Coke & Conough Offsite Ransion

CITY OF LAS VEGAS INTER-OFFICE MEMORANDUM		DATE: June 12, 2012
TO: Land Development Services Department of Public Works		FROM: Albert Sung, P.E. Flood Control Project Engineer Department of Public Works
SUBJECT:	Drainage Study for:	
	Coke & Conough Offsite Revision	
Cross Streets:	NWC of Coke & Maggie	
File Number:	F:\Depot\DSMemos\DS4554.doc	
Parcel Number:	125-09-510-001 to -019	
Zoning Action:		
FEMA Flood Zone	YES	NO X
Proposed Storm Drain	YES	NO X
		COPIES TO: Dwyer Engineering WGP Investment Group Bart Anderson, P.E., DevCo

Supplement #1 to the Technical Drainage Study for Coke & Conough

Re: Supplement #1 to the Technical Drainage Study for Coke & Conough

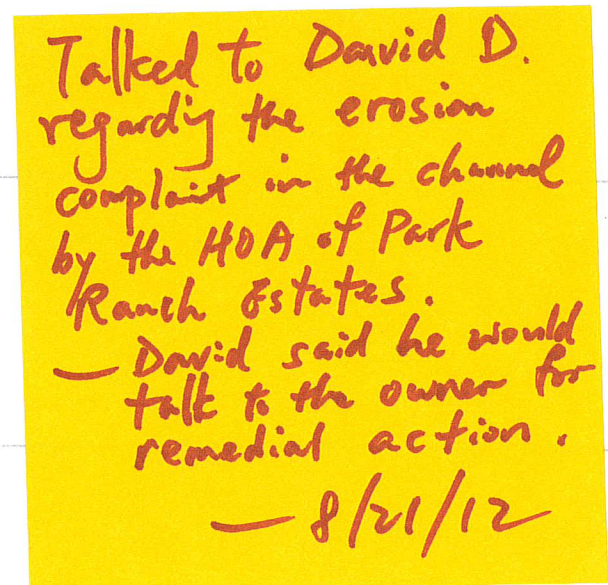
It's a question for your planning/compliance folks I think. The new sub division to our west is draining into the drain behind our houses on Lake Louise Ave. Right now it is a dirt drain and some of the material is being transported downstream due to the rains.

I've attached a picture of the concrete bottom, rip rapped drain. The July picture is the upstream concrete the western developer put in to drain from the homes. You can see the material movement.

Talked to David D.
regarding the erosion
complaint in the channel
by the HOA of Park
Ranch Estates.
— David said he would
talk to the owner for
remedial action.
— 8/21/12

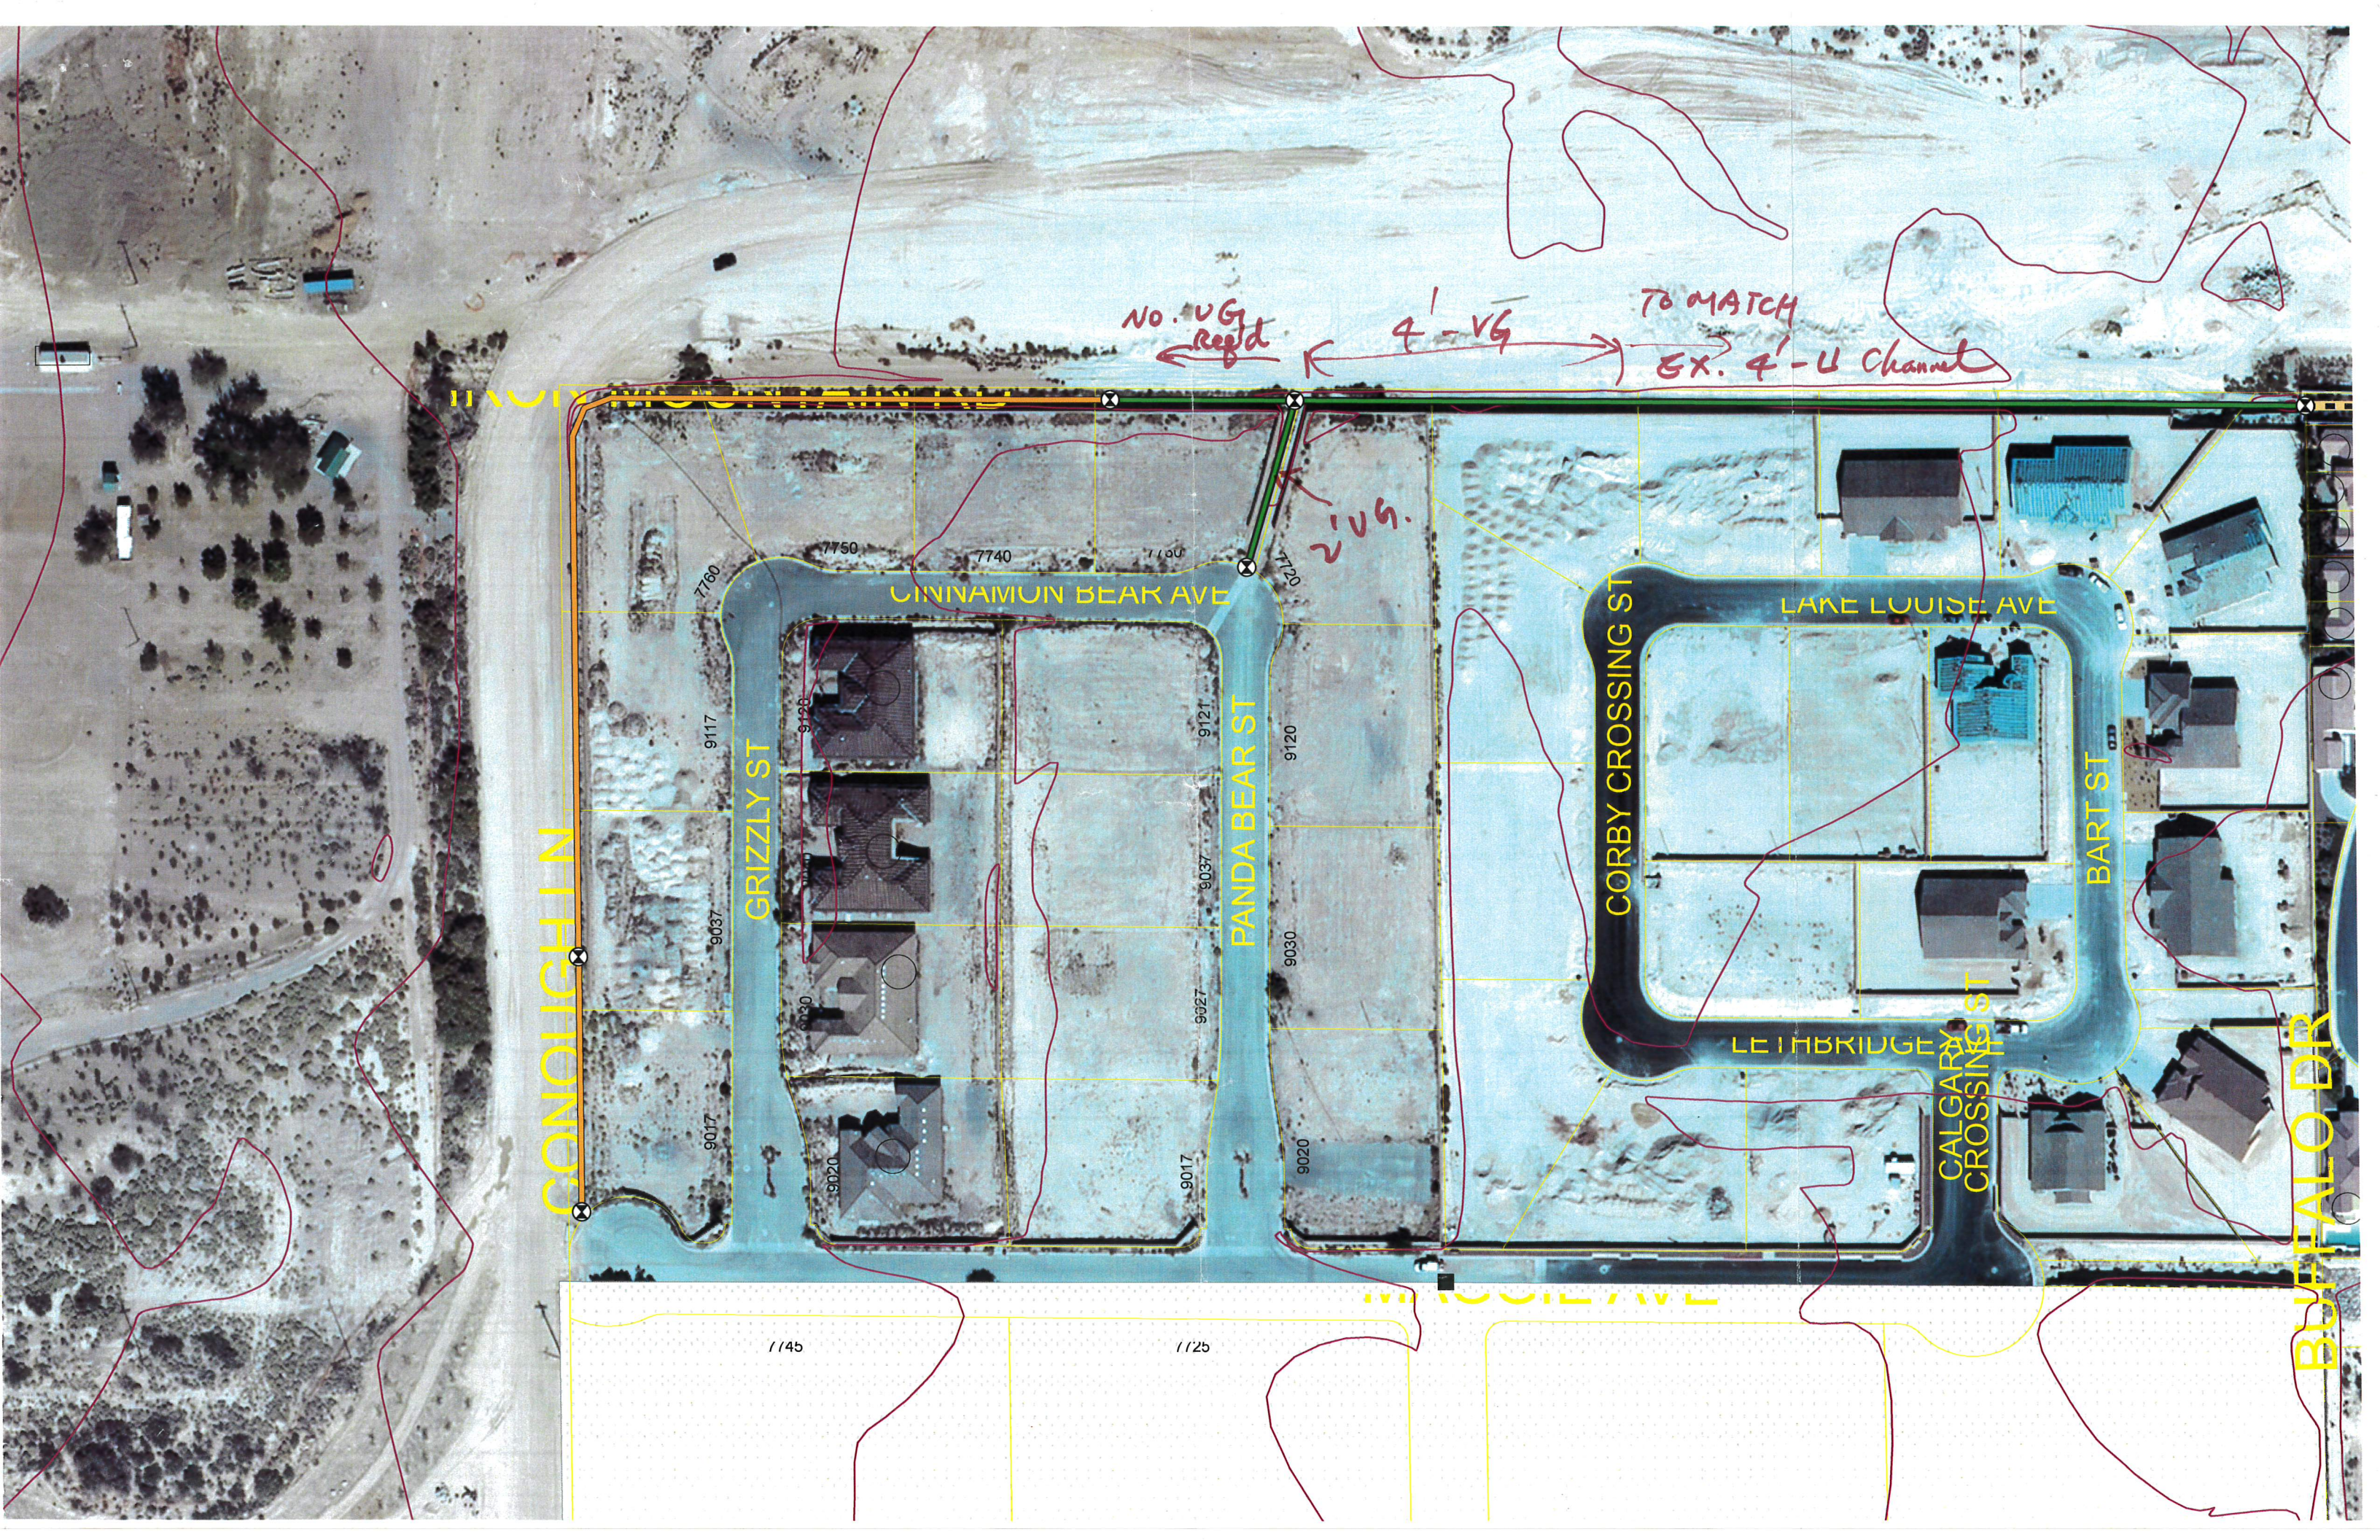
Item #1: Offsite nuisance flows adjacent to the site on the North PL and West PL.

-Visual inspection has determined that there are NO nuisance flows coming toward the subject site from the adjacent property(s). No concrete valley gutters or any concrete drainage facilities will not be needed or required. This will require civil plan revisions to sections U/6, J/6, K/6, and L/6. All said sections show a 4-ft wide u-channel which will not be built.

Item #2: Section M/6.

-A 2-ft wide valley gutter is to be built (in lieu of the 4-ft concrete u-channel) in the middle of the section to handle on-site nuisance flows. The 2 ft-wide valley gutter is to transition into a 4 ft-wide valley gutter and the 4 ft-wide valley gutter is to transition into the existing 4 ft-wide U-channel that is located northeast of our project site. Transition details to be provided on the revised civil plans. M/6 will still have riprap as needed for the 100-yr storm. Wrought iron fence is to be built on each end of the channel as shown on the approved civil plans. Mr. Sung said protection bollards are also acceptable (in lieu of the wrought iron fence) on the project street side if so desired by the owner. The owner has indicated that bollards are desired in lieu of the wrought iron fence.

Item #3: North and East PL sections with respect to the 100-yr storm design.

-Drainage calculations will need to be done and incorporated into the drainage study before determining what said sections will be. If it is determined that the 100-yr flows are less than 5 fps (feet per second) then no rip-rap will be needed and the contractor will just have to grade a compacted dirt landscape swale. If the flows are greater than 5 fps then rip-rap will be needed and the riprap size requirements will be determined by the 100-yr flows.

FIGURE 2

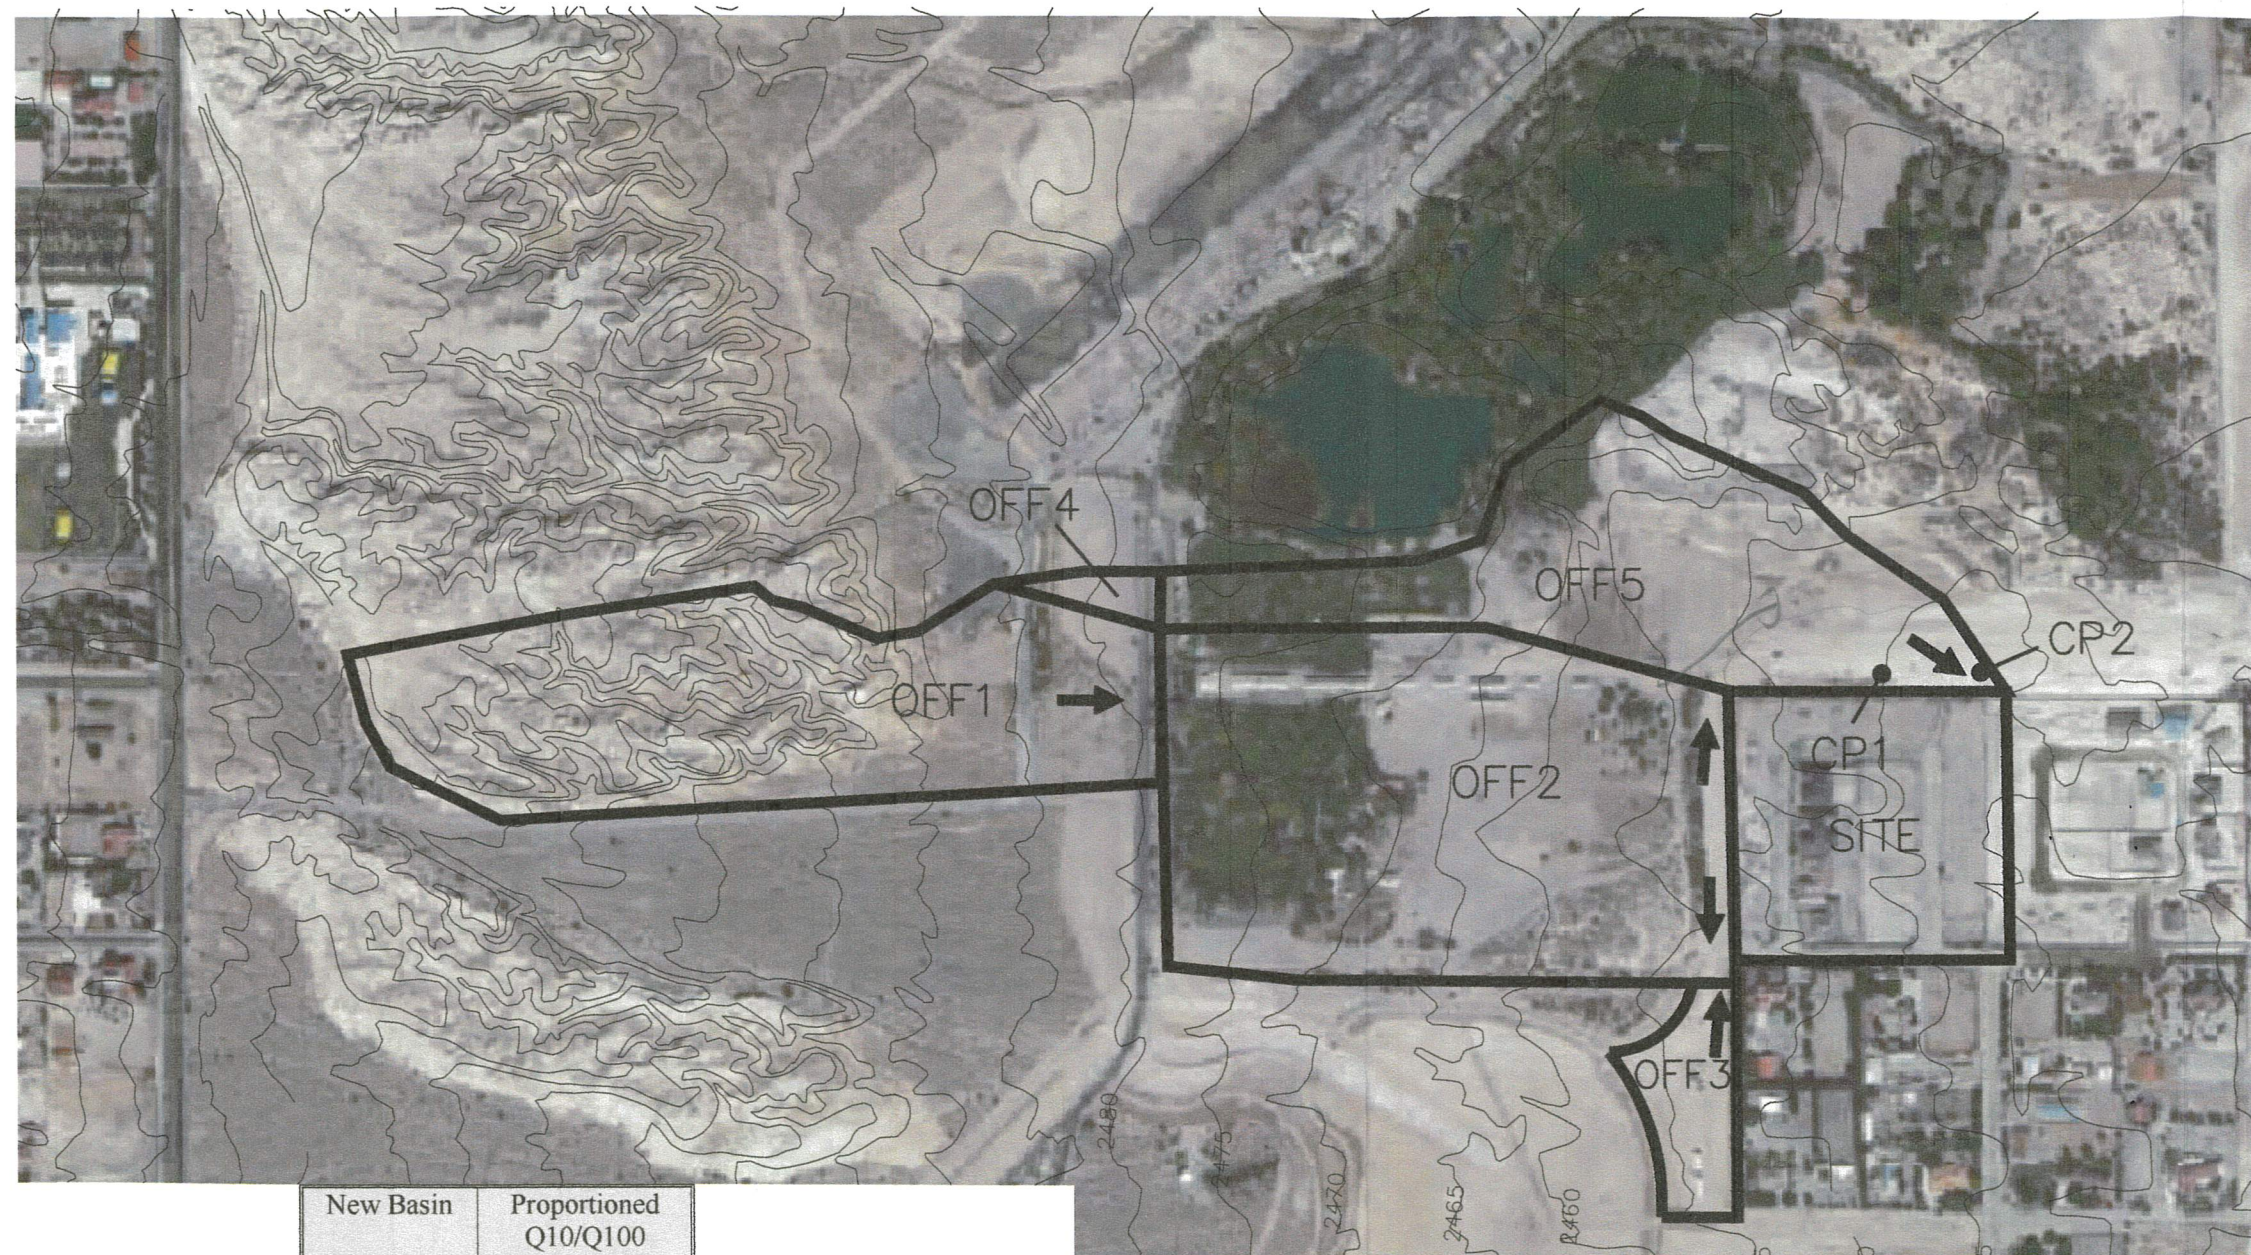
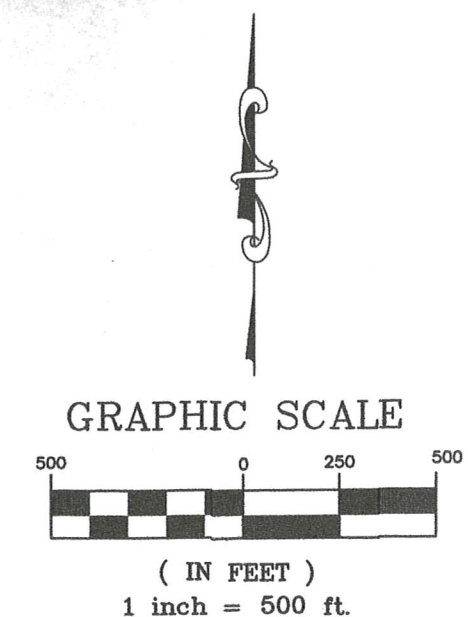
Informed Phil W. to revise the offsite Basin Map to include an offsite basin to the north and revise all pertinent hydraulic calcs. - 5/15/12

As discussed, we have further investigated flows impacting the northern boundary. Basins OFF4 and OFF5 have been added and have been delineated based on basins from the Floyd Lamb Park North and South Environmental Enhancement Areas Final Design Report and Clark County 5-foot contours (see revised Figure 2). The following is a summary of the revised flows:
